ADDENDUM No. 1
to
Crook County Courthouse Electrical Upgrade
Request for Proposals

Date: March 15, 2023

The following changes, additions, and/or deletions are hereby made a part of the Request for Proposal Documents for the Courthouse Electrical Upgrade project in Crook County, Oregon dated February 28, 2023, as fully and completely as if the same were fully set forth herein.

TO ALL PROSPECTIVE BIDDERS:

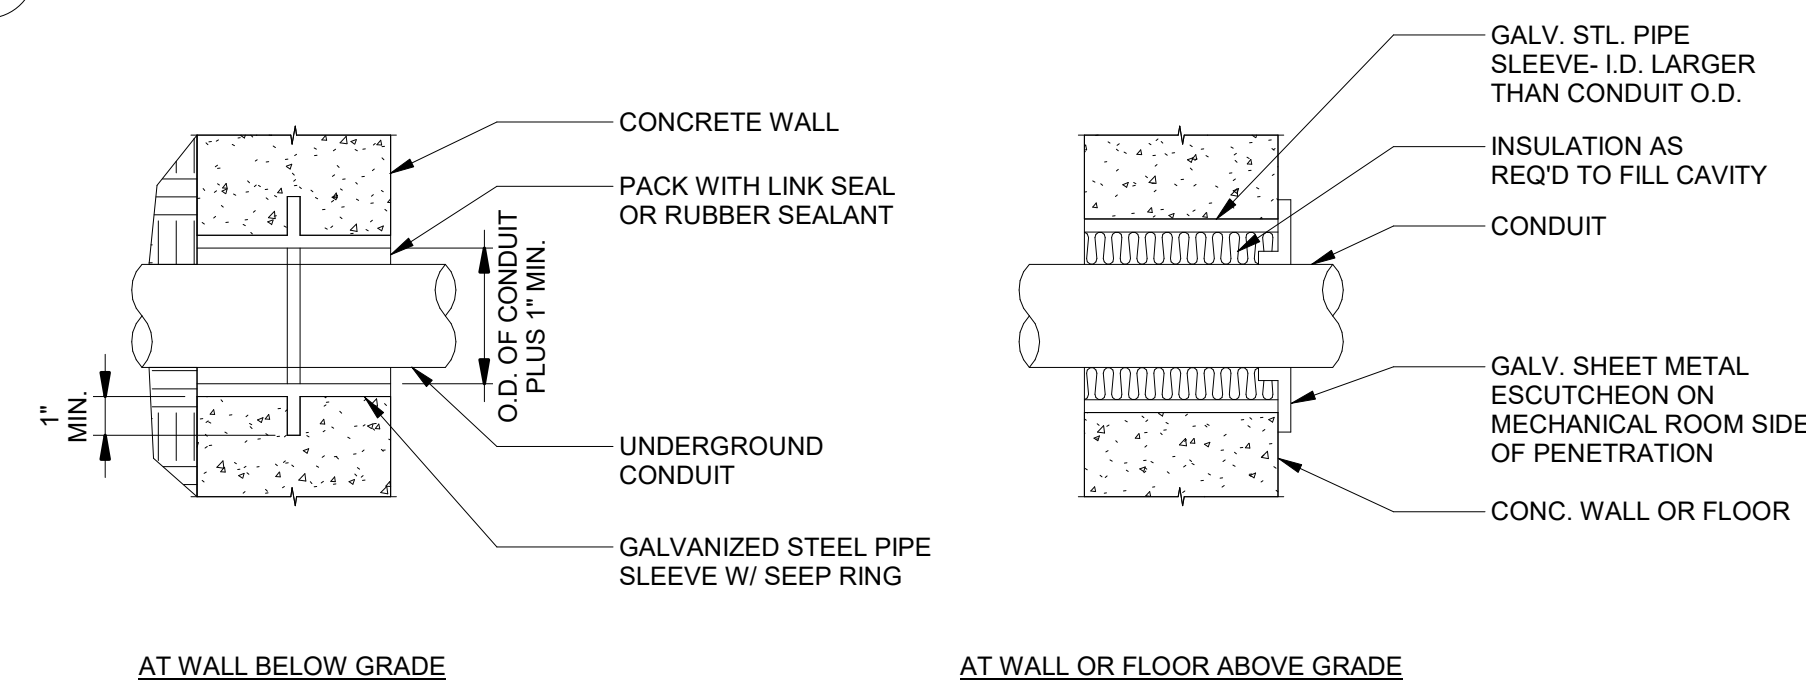
1. **Revised Sheet E-3** attached, note the following changes:
 - a. Instead of two options, there is now just one configuration for the service.
 - b. Key notes were changed to correspond with the revised service one line diagram.
 - c. The electrical service **will remain an overhead service**, but a new weatherhead will be installed to allow for modifications.
 - d. Relocation of the overhead service drop will need to be coordinated with the electrical utility.
 - e. An exterior junction box will be installed near the new disconnect switch and power will be routed through this to the existing Panel NDP.
2. Contractor to obtain permit. Crook County to reimburse for cost.
3. The existing ADA parking space located at the east side of the electrical/boiler room will be relocated to allow for installation of new electrical gear.
